Comments on the AES Response to FEIR criticisms

Daniel Axelrod

Nov. 12, 2017

An alternative reasonable hydrodynamic model producing opposite conclusions from Theis

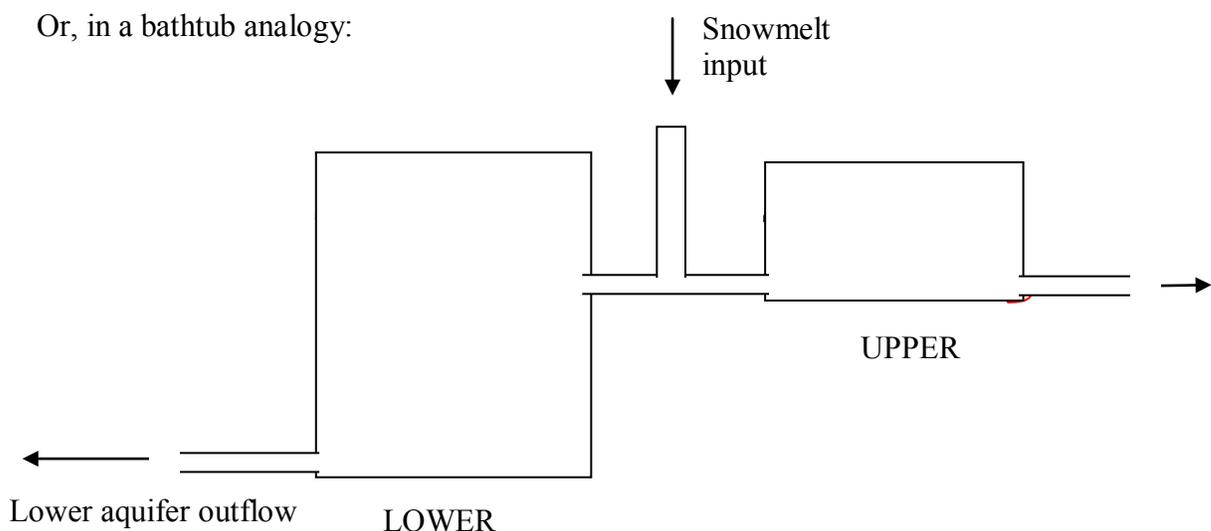
This argument might be valid if there were no other reasonable models. But is not the following model reasonable? This made-up non-Theis model is intended to show that increasing the flow into the "lower aquifer" (which DEX-6 and the domestic well are presumed to draw upon) by pumping may reasonably decrease the flow into the upper aquifer (residential wells).

Assume both aquifers draw upon the same source, snowmelt on Mt. Shasta. The average flow rate is fixed, limited by the average melt rate. At some point on the underground journey downhill, that fixed flow is apportioned between upper and lower aquifers. Pulling the lower aquifer down by pumping will decrease its pressure and thereby increase flow into that route, at the expense of the upper route. It is even conceivable (in principle) that the lower aquifer pumping may completely deplete the upper aquifer. For example, say that 90% of the water goes into the lower and 10% into the upper. Increasing the flow in the lower by 10 % (say, by DEX-6 pumping) will increase its % to 99% and rob the upper down to 1%. The change is near-negligible for lower aquifer levels but catastrophic for upper aquifer levels.

Pumping on the "lower aquifer" brings the level down in the left bathtub from the black squiggly line to the red. This does not seriously deplete the lower outflow. But the upper outflow is sharply reduced.

Another way of looking at this is that the level in the upper aquifer is supported by hydrodynamic pressure from below, even if the hydrodynamic connection is "limited". If that pressure from below is reduced by industrial-scale pumping, the level in the upper will drop.
